City of El Paso – City Plan Commission Staff Report

Case No:	SUSU13-00109 Stevens Addition Replat "B"
Application Type:	Resubdivision Combination
CPC Hearing Date:	December 19, 2013
Staff Contact:	Raul Garcia, (915)541-4935, garciar1@elpasotexas.gov
Location:	West of Santa Fe Street and South of I-10
Acreage:	7.66 acres
Rep District:	8
Existing Use:	Public Facilities (Ballpark)
Existing Zoning:	C-5 (Commercial/ special permit) & M-1 (Industrial) & A-3 (Apartments)
Proposed Zoning:	C-5 (Commercial/ special permit) & M-1 (Industrial) & A-3 (Apartments)
Nearest Park:	Cleveland Square Park (adjacent to east)
Nearest School:	Vilas Elementary School (0.45-mile)
Park Fees Required:	$270.00 (Credit is being applied for previously paid park fees)
Impact Fee Area:	This property is not in an impact fee area and is not subject to impact fees.
Property Owner:	City of El Paso
Applicant:	City of El Paso
Representative:	Conde, Inc.

ATTACHMENT 3

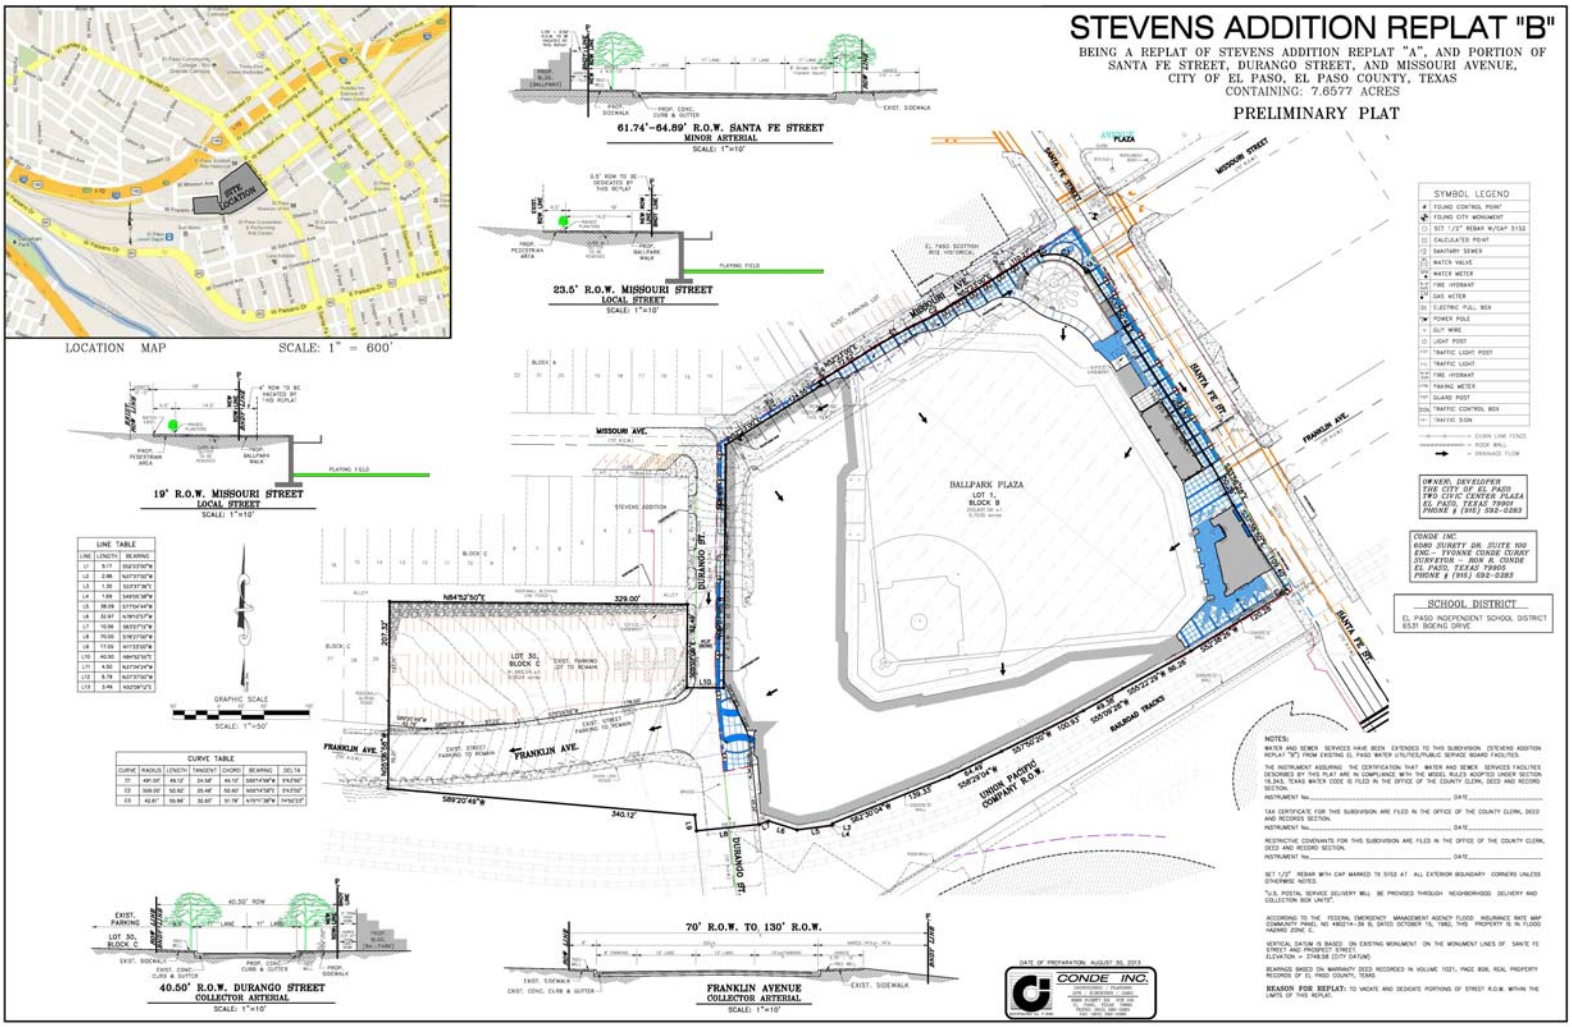
1. Label all topographic contours and elevations on preliminary plat.
2. Show and label all existing and proposed drainage structures.
3. Verify and dimension the minimum and maximum sidewalk widths are being provided along both sides of Franklin Street, Santa Fe. Street, and particularly along Missouri Street.
4. Show proposed runoff direction on typical street cross sections.
